Staff Report

Re: Petition PLNHLC2020-00103, 33rd Ward Minor Alterations

MINOR ALTERATIONS

Property Address: 453 S. 1100 East
Parcel IDs: 16-05-408-057
Historic District: University
Zoning District: I - Institutional
Master Plan: Central Community Master Plan - Institutional

SHEET TITLE:
GRADING & DRAINAGE PLAN

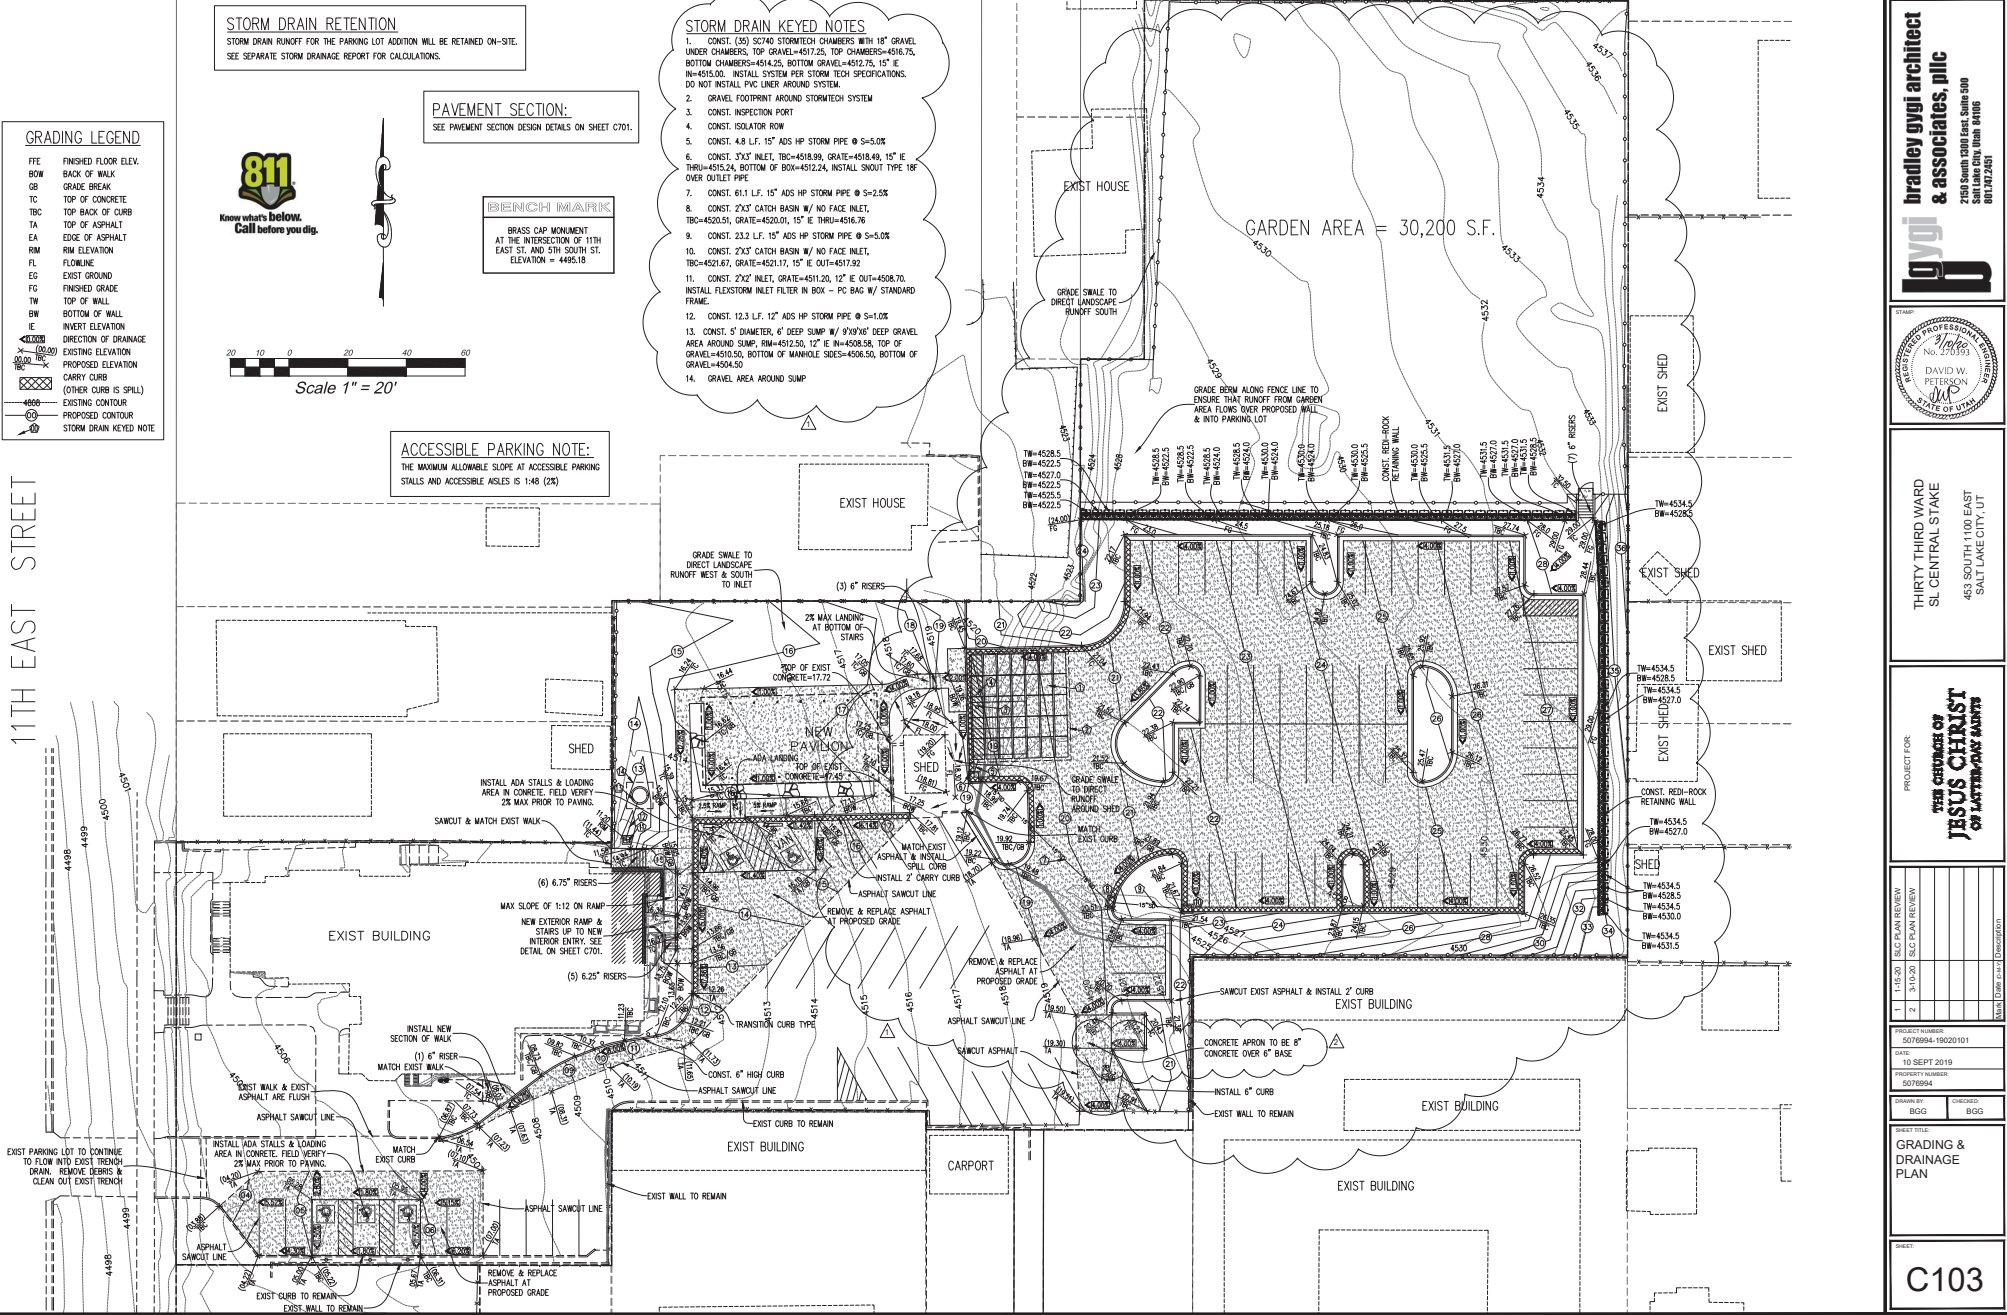
Plans will need to be submitted for review and approval. The grading and drainage plan will need to include a technical drainage memo to address current standards. The stormwater from the new parking area will need to be treated prior to discharge. The plan can be submitted as part of the building permit process. I don't see anything on the plans that should hold up the HLC approval.
